Entergy Nuclear Generation Co.
Pilgrim Nuclear Power Station
600 Rocky Hill Road
Plymouth, MA 02360

**REQUEST FOR LICENSE CHANGE CONCERNING ECCS NPSH
AND BULLETIN 96-03 SUBMITTAL**

Updated NPSH Evaluation for RHR and Core Spray Pumps

Figure 1

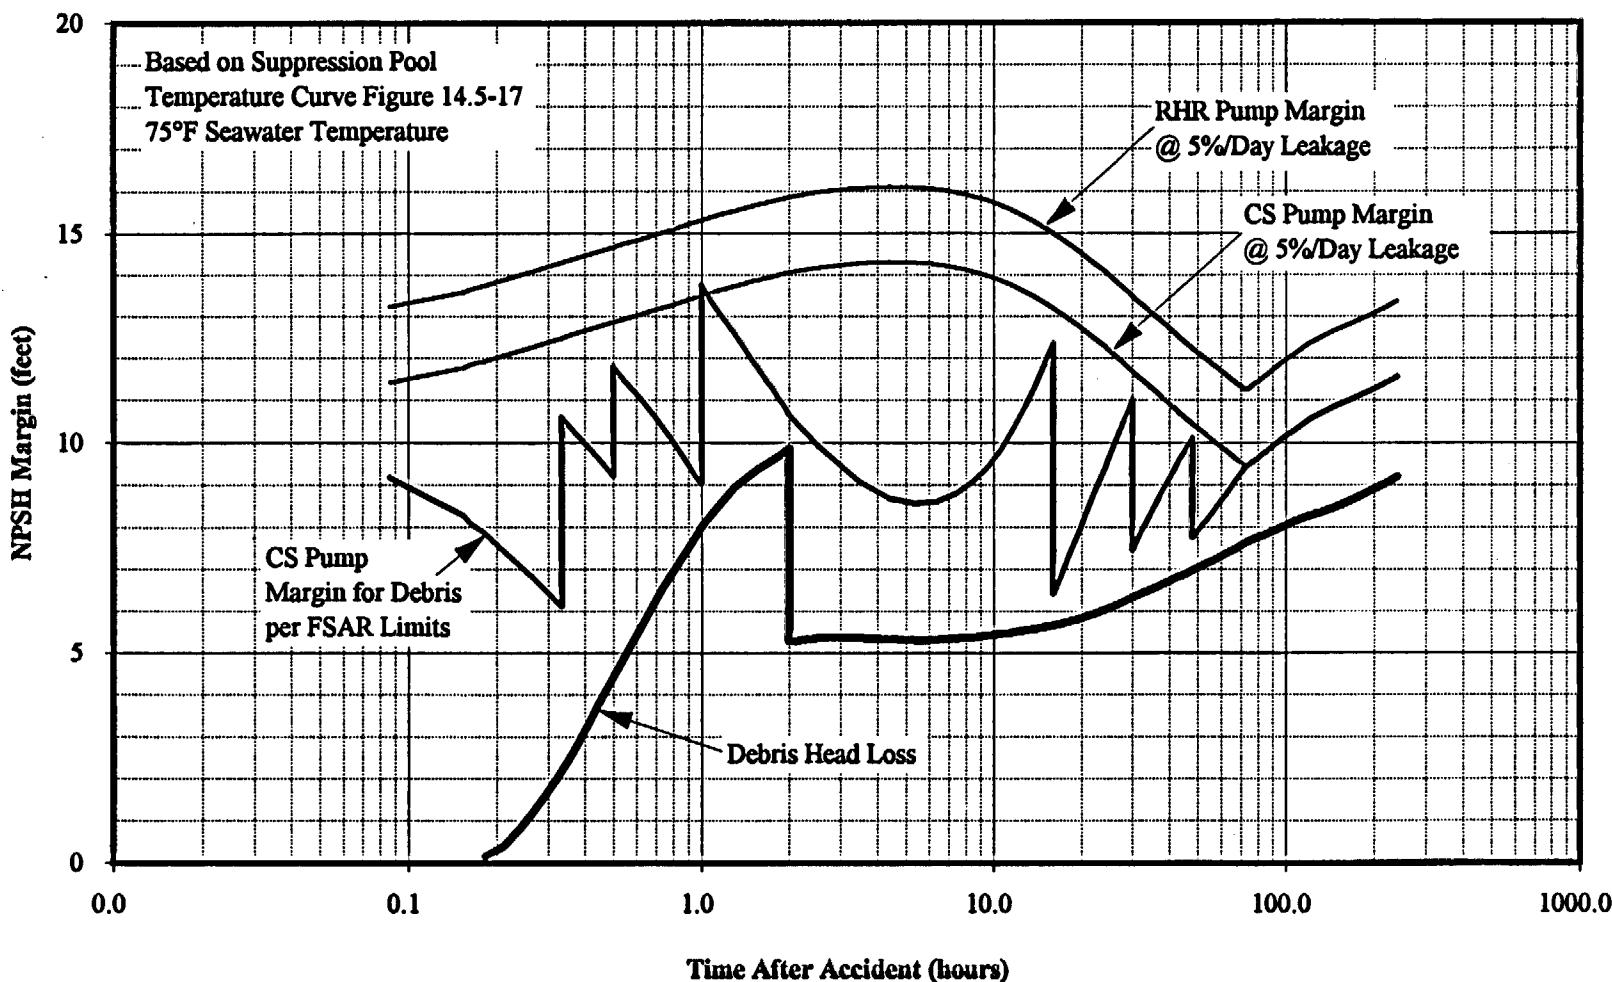
The results from the DBA-LOCA NPSH analysis are illustrated in attached Figures 1 and 2. Figure 1 shows the containment pressure available and the pressure required to provide adequate NPSH to the RHR and core spray pumps with a clean strainer and with the new debris head loss included. The new proposed FSAR containment pressure limits are also shown on Figure 1. The core spray pumps are more limiting for NPSH than the RHR pumps. Figure 2 shows, in units of feet, the corresponding total NPSH margin available with a clean strainer, the postulated debris head loss, and the margin available for the most limiting ECCS pump based on the proposed FSAR containment pressure limits. The total NPSH margin depicted in the figures is based on the conservative lower bounding containment pressure existing due to thermal equilibrium principles for an enclosed volume (primary containment) as described in FSAR Section 14.5.3.1.3.

The most limiting case DBA-LOCA analysis assumes that the second RHR pump is shut down after the first two hours. As shown on Figure 1, the curve for containment pressure required with debris meets the 5.0 psig limit at this point in time. It is not necessary to assume more than the proposed 5.0 psig limit since shutting down the second RHR pump will mitigate any cavitation that occurs due to the maximized flow rate of three pumps.

It is proposed the containment pressure that may be assumed in pump NPSH and suction strainer evaluations be limited in the FSAR to the following pressure profile:

Time After Accident (sec)	Containment Pressure (psig)	Containment Pressure (psia)	
(hour)			
0 to 1,200	0.0 to 0.33	0.0	14.7
1,200 to 1,800	0.33 to 0.50	1.9	16.6
1,800 to 3,600	0.50 to 1.0	3.0	17.7
3,600 to 57,600	1.0 to 16.0	5.0	19.7
57,600 to 108,000	16.0 to 30.0	2.5	17.2
108,000 to 172,800	30.0 to 48.0	1.0	15.7
172,800 to 864,000	48.0 to 240.0	0.0	14.7

Figure 2

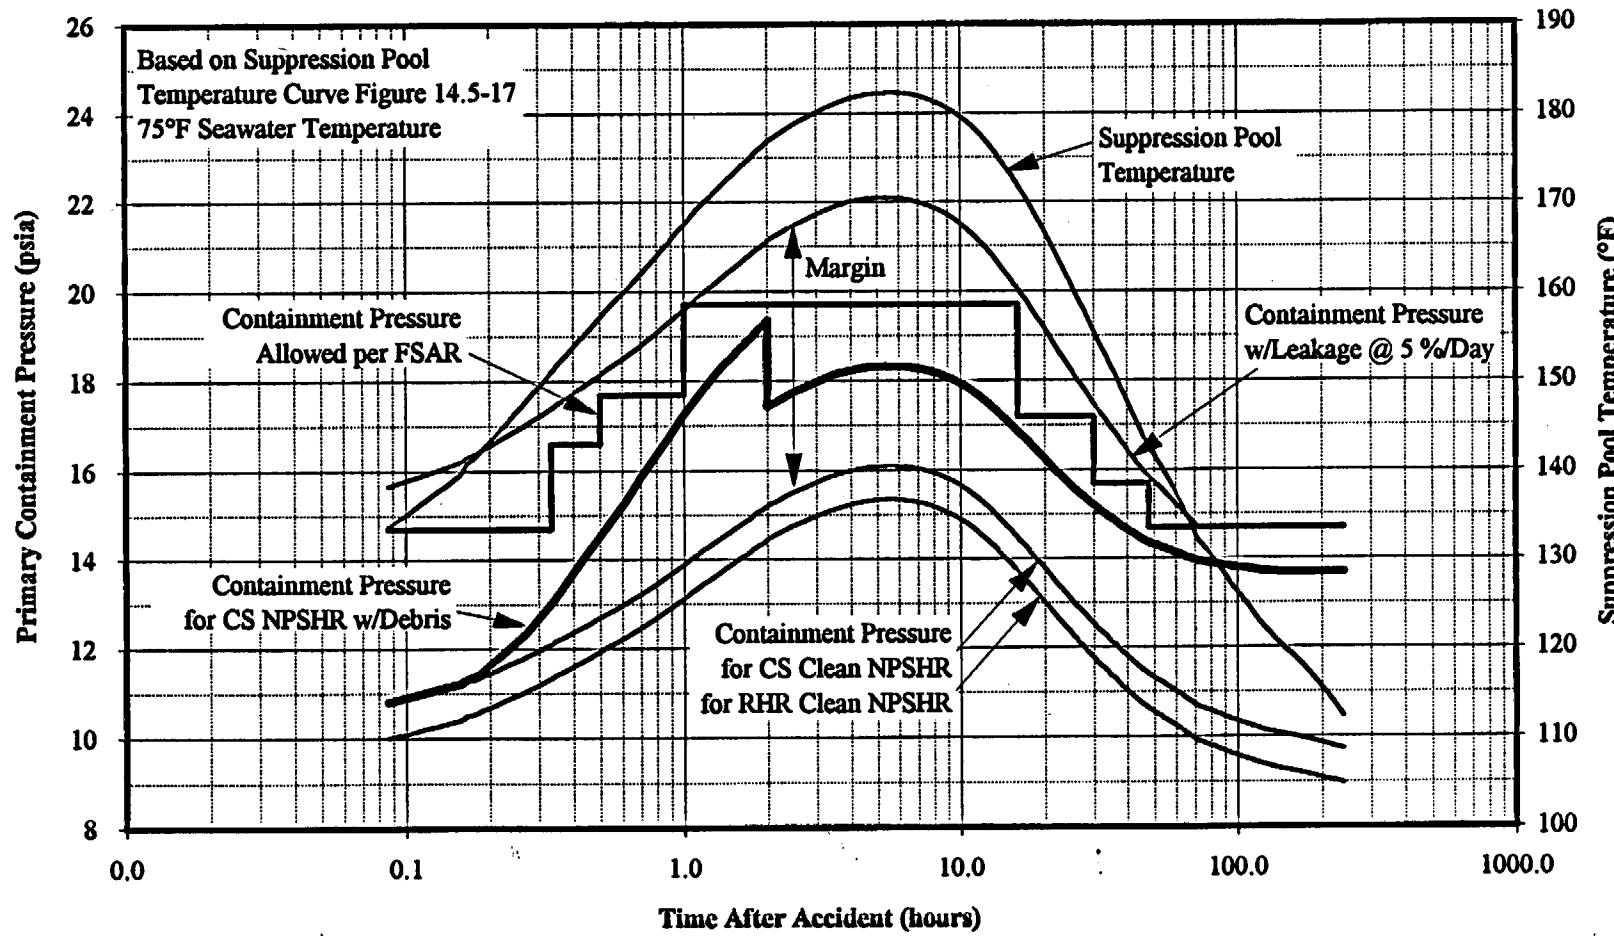
As illustrated in Figures 1 and 2, the proposed FSAR containment pressure limits provide sufficient NPSH margin to accommodate the new debris head loss. The proposed FSAR limits are less than the available containment pressure determined using the thermal equilibrium method. These NPSH calculations are based on the suppression pool temperature profile for the DBA-LOCA with a 75°F SSW heat sink, which has a peak pool temperature of 182.3°F. In addition, NPSH was evaluated at the design peak suppression pool temperature of 185°F and the 5.0 psig proposed limit provides sufficient margin for the RHR and core spray pumps with the DBA-LOCA debris head loss at that point in time.

It is also shown on Figure 2 that the FSAR limits are not intended to include the additional two feet of NPSH margin allocated to uncertainty and pump inservice testing (IST) as described in Calculation M-662. However, there is a two foot or greater NPSH margin between the debris head loss profile and the margin provided by the containment pressure as determined in Calculation M-662 using the FSAR thermal equilibrium method up to and through the peak pool temperature and at all times during the first 48 hours after a DBA-LOCA. The 48 hour period of time is significant because containment positive pressure (overpressure) is credited for providing sufficient NPSH up to 48 hours. The NPSH margin based on the proposed FSAR pressure limits is intended to envelop the bounding DBA-LOCA strainer debris head loss. The two foot head loss allocated to IST represents additional margin provided to account for uncertainty and it is considered sufficient to demonstrate that this unused margin exists during the period of time that containment pressure greater than atmospheric is credited.

The two hour point is also conservative because it is approximately the amount of time needed to accumulate all the available debris in the suppression pool onto the strainer. Therefore, should the two-pump LPCI mode be continued for longer than two hours there would not be a significant increase in the debris head loss above the value at the two hour point until the pool begins to cool down after six hours have passed. Furthermore, upon shutting down the second RHR pump beyond two hours the resulting debris head loss would not be significantly greater than given on Figure 2 for the same point in time.
